## PRODUCT CHANGE NOTIFICATION

PCN Number: 431

Title of Change: Datasheet Update for L59U Series

Old Product Dimensions:

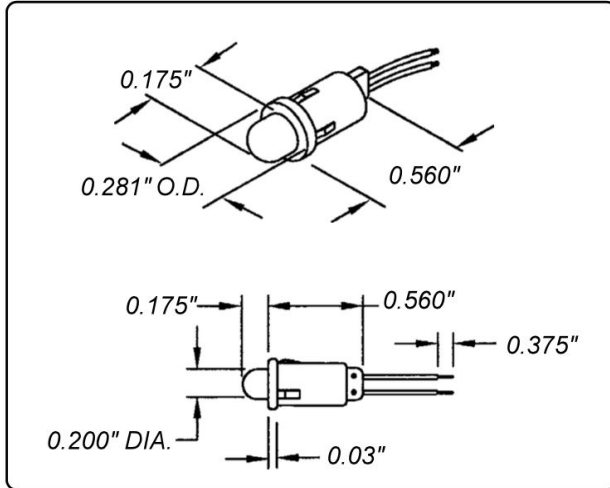
Reason of Change: The dimensions of the product and the recommended thickness of the panel are updated. The updated datasheet is available on the website. The last page of this Product Change Notification shows the changed dimensions.
